SERVICE BULLETIN

Replacement of fuel pumps for ROTAX® Engine Type 912 (Series)

I This SB revises the revision 1 dated 24 June 2013.
ATA System: 73-00-00 Fuel system

| This SB revises the initial issue dated 24 June 2013.

Fig. 1

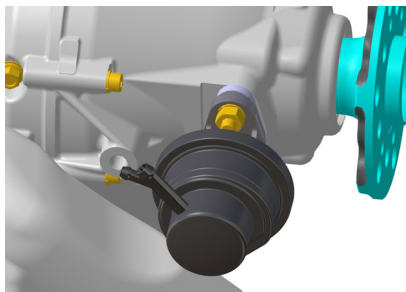
3.1.1) Removal of fuel pump part no. 892542 (without crimped hose assembly), see Fig. 1

Step	Procedure
1	Remove fuel hoses as per aircraft manufacturers instructions. NOTE: Make note of orientation of the hoses (inlet/outlet).
2	Loosen hex. nuts (13 mm/0.51 in) and remove fuel pump with lock washer A8 and insulating flange (gasket).

Fig. 2

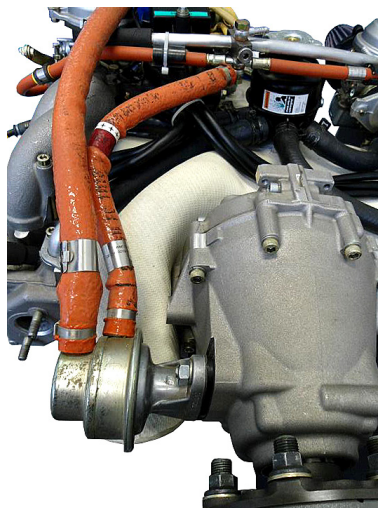
3.1.2) Removal of fuel pump part no. 892546 (with fire sleeve), see Fig. 2

Figure shows fuel pump part no. 892546 with crimped fuel hose assy. and fire sleeve.
Fuel pump

Fig. 3

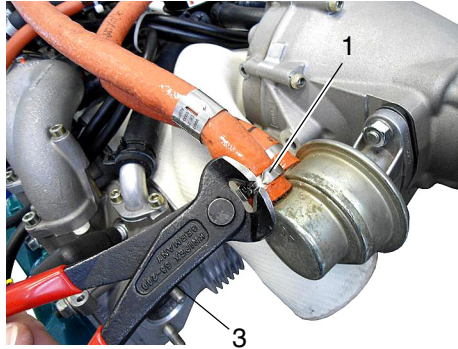
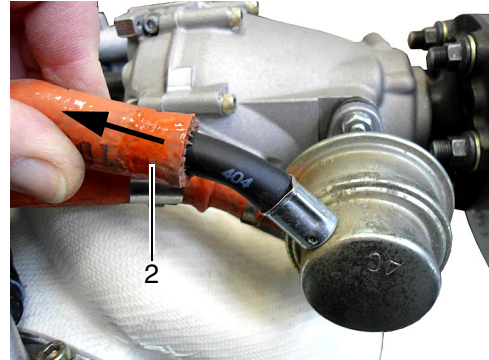
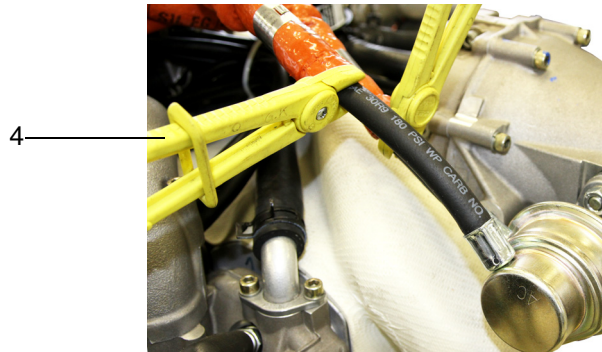
The following work steps are necessary (see Fig. 3):

Step	Procedure
1	Cut off the 1-ear clamp (1) of fire sleeve (2) with cutting pliers (3).
2	Slide back the fire sleeve (2) to make fuel hose accessible for cutting.
3	Pinch off the fuel hose with hose clamp pliers (4).

Fig. 4

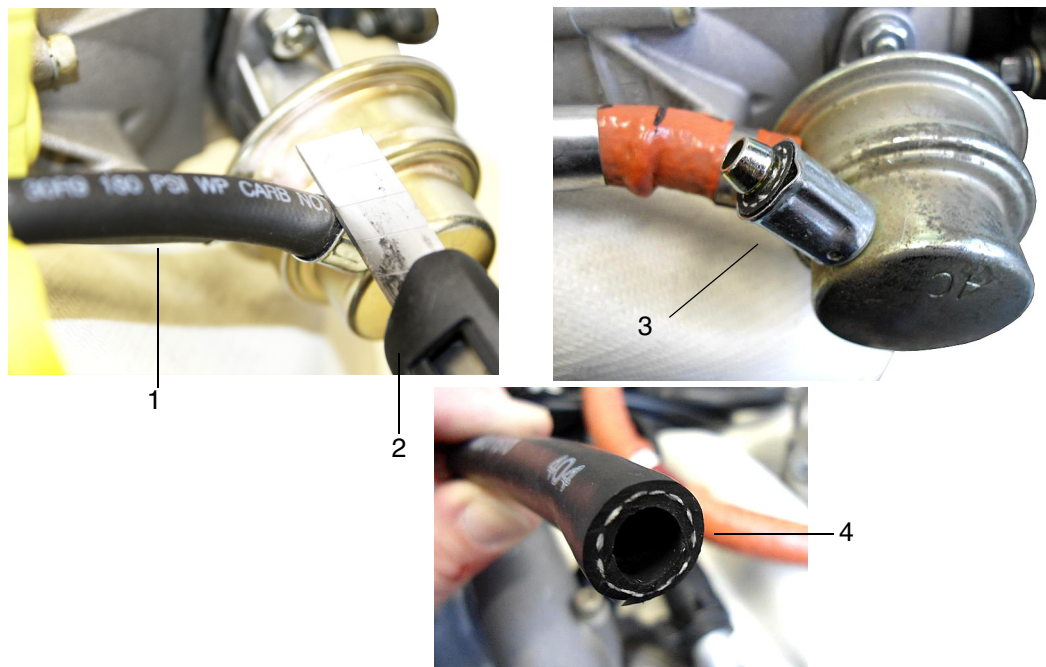
NOTE: Cut off the fuel hose with a very sharp knife, so that no cutting residues are produced. See Fig. 4.

Step	Procedure
4	The cut should be made adjacent to the crimped ferrel, to avoid losing any needed length. The fuel hose is reduced by approx. 20 mm (0.79 in.). NOTE: Make note of orientation of the hoses (inlet/outlet) A clean cut surface is very important!
5	Repeat procedure at the second fuel hose assy.

Fig. 6

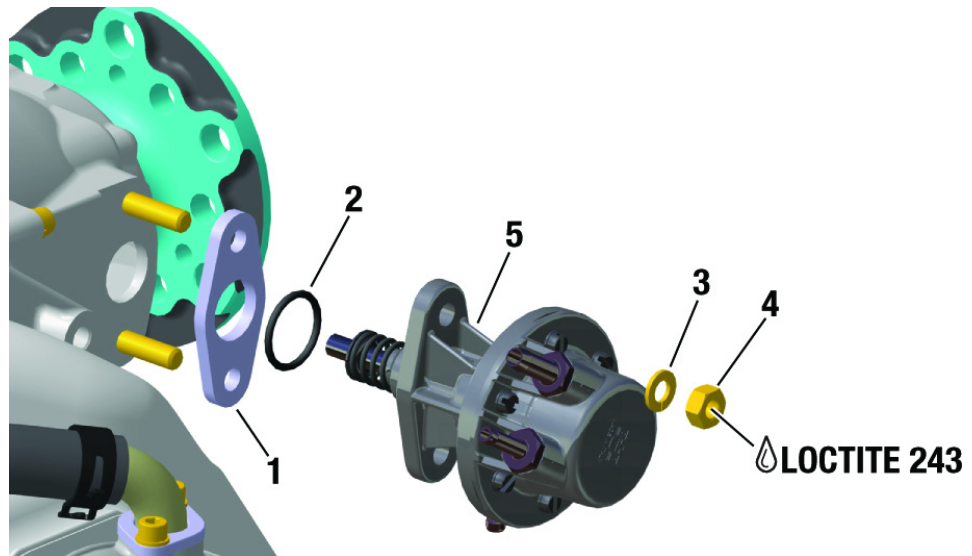
3.2) Assembling of fuel pump assy. part no. 893110

In addition to the insulating flange (gasket) also replace the O-ring at reassembly or assembly of the fuel pump. Both parts are included in the set of fuel pump assy.

Ensure the O-ring is located in the recess in the fuel pump, before installing the fuel pump!

Step	Procedure
1	Install fuel pump (5) with new insulating flange (gasket) (1) and O-ring (2).
2	Secure new hex. nuts M8 (4) and lock washer A8 (3) with LOCTITE 243 and tighten them evenly. Tightening torque 15 Nm (133 in.lb).

Fig. 7

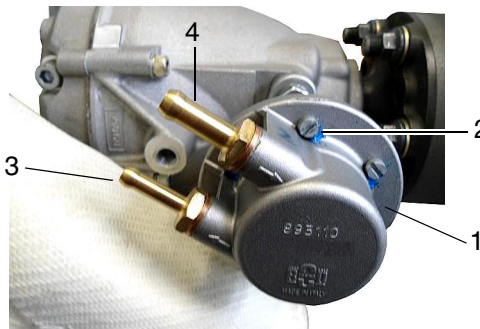
The fuel pump cover (1) must not be opened for inspection. Check the security markings (witness paint) (2).

Check the connecting nipples (3)+(4) for tightness. If necessary secure them with LOCTITE 243. Tightening torque 10 Nm (88.5 in.lb).

Step	Procedure
1	Connect the hose from the fuel tank to the connecting nipple identified as 4 in Fig. 7.
2	The hose that goes to the carburetors should be connected to the connecting nipple identified as 3 in Fig. 7. NOTE: After installation of the hoses ensure the fuel tap is turned back ON.

Fig. 8

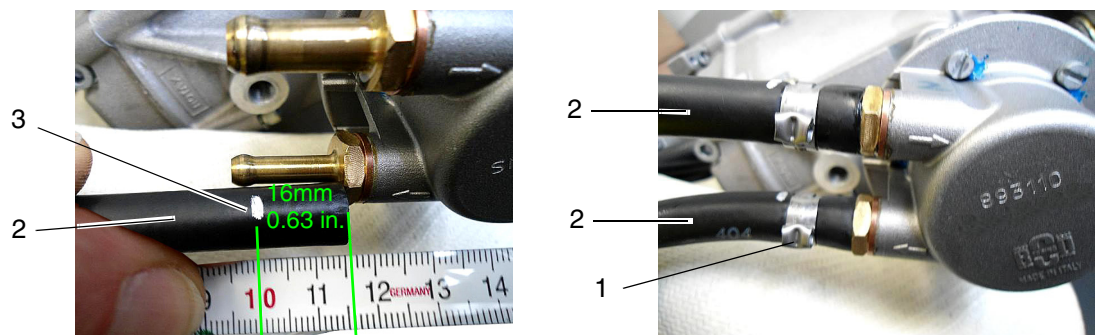
3.4.2) Assembling of the fuel pump part no. 893110 when replacing fuel pump part no. 892546

Step	Procedure
1	Remove hose clamp pliers from fuel hose assy.

Step	Procedure
2	Before the fuel hose (2) is fitted with a 1-ear clamp (1), the two fuel hoses have to be marked (3) 16 mm (0.63 in.) from the end of the hose (2).
3	Slide all 4 1-ear clamps (1) on the fuel and fire sleeves. NOTE: Clamps part no. 853313/851663 on fire sleeve and clamps part no. 851463/851453 on fuel hose.
4	Slide the fuel hoses (2) onto nipple completely up to the end stop.
5	Crimp 1-ear clamp (1)- outlet side part no. 851463 with suitable crimp pliers . NOTE: The edge of the 1-ear clamp (1) must align with mark (3) from fuel hose (2) , because otherwise there is too little space for the 1-ear clamp (1) of the fire sleeve.
6	Repeat steps on inlet-side with 1-ear clamp (1) part no. 851453 for fuel hose assy. (2).

Fig. 9

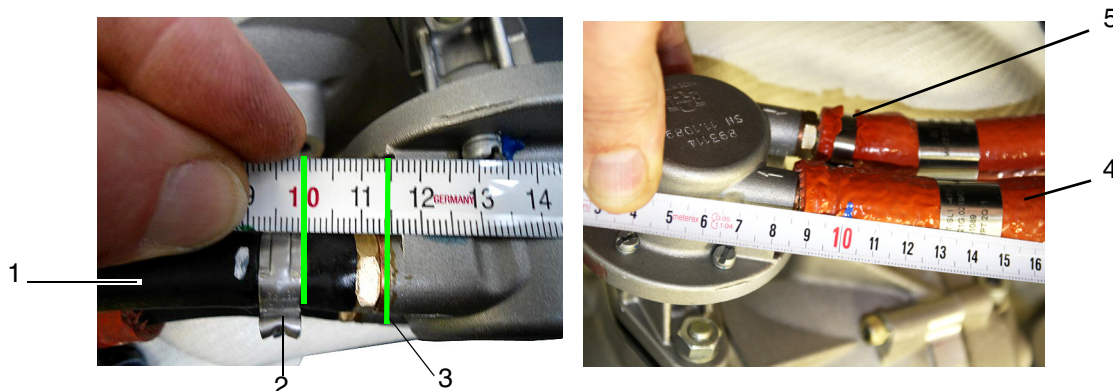
The distance from the 1-ear clamp (2) to the nipple flange (3) has to be measured, so that the outer 1-ear clamp (5) can be mounted on the fire sleeve (4) in the correct position.

Step	Procedure
1	Measure the distance at fuel hose assy. (1) from 1-ear clamp (2) to nipple flange sealing surface (3) and mark the fire sleeve (4) correspondingly. NOTE: The clamp securing the fire sleeve should be as close as possible but without impeding on the fuel hose clamp

Fig. 10

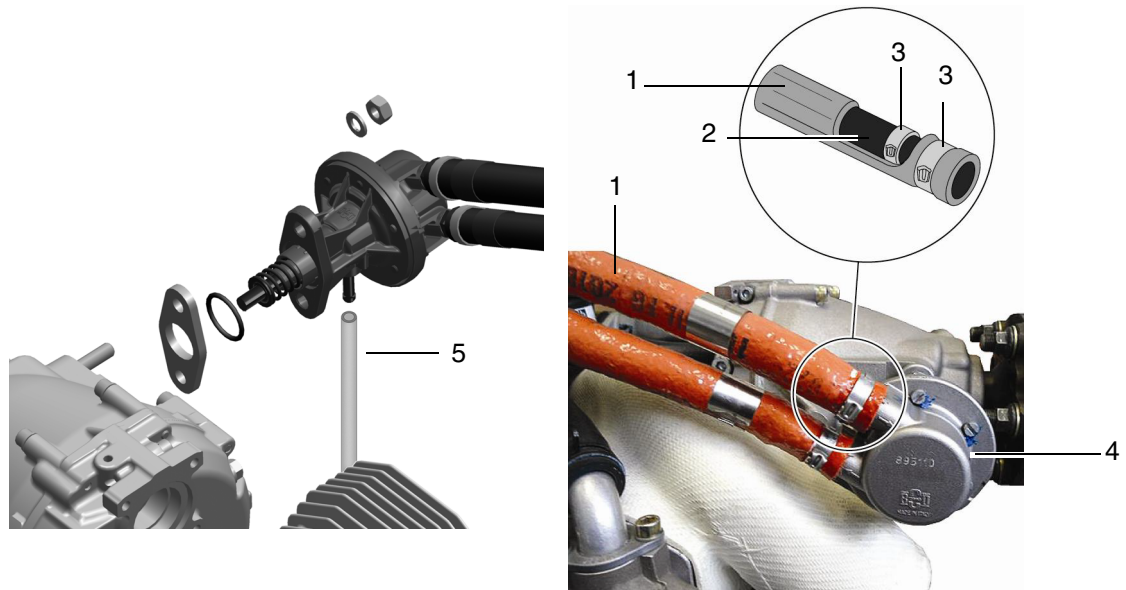
Step	Procedure
2	Push fire sleeve (fuel inlet) to stop and mount 1-ear clamp (17.8-21.0 mm/0.70-0.83 in.) with suitable crimp pliers.
3	Repeat steps for fire sleeve (fuel outlet) (22.4-25.6 mm/0.88-1.01 in.).

A drain line must be installed, that in the event of a internal leak any fluid is drained to a suitable location/position. See therefore Installation Manual of the relevant engine type and SI-912-020.
